Service Bulletin

Bulletin No: 2003-1-23 Subject: Coolant Drain Hose Location

Affected Models / VIN: Model: 2003 Mountain Cat 900 (159 in.)

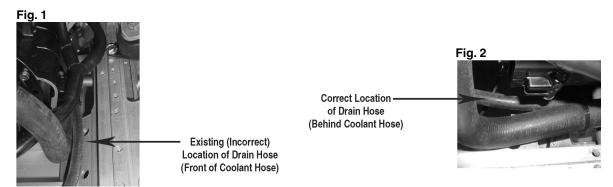
It has been determined that existing Coolant Drain Hose (p/n 0610-076) located at the front of the engine is incorrectly routed and may come into contact with the sharp edge of the chassis. This condition may cause possible damage to the hose. See Fig. 1 for <u>incorrect</u> routing of drain hose.

Solution: Reroute the coolant drain hose <u>behind</u> the coolant tank-to-engine hose. See Fig. 2 for the correct

routing of drain hose. Also, at this time, make sure the drain hose plug (white) is not located

near the resonator. Using a cable tie, secure the drain plug away from the resonator.
